**Appearance change of the label laminating material**

We would like to inform that we will change the label laminating material of Electronic multi-measuring instrument.

Product name	Model name
Electronic Multi Measuring Instrument	ME96SSEB-MB, ME96SSRB-MB, ME96SSHB-MB

※1 The above is an example of ME96SSRB-MB name plate label.

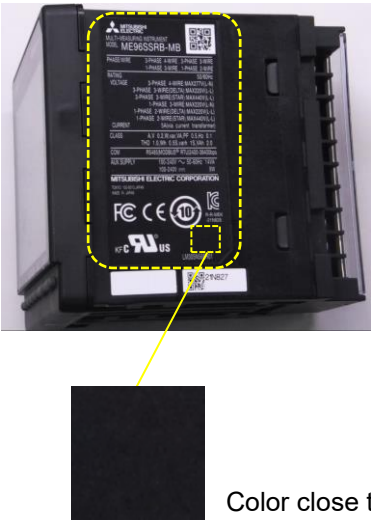
Appearance color of the name plate label and the terminal label has been changed due to change of the label laminating materials.

Item	Before change	After change
Appearance color ※1
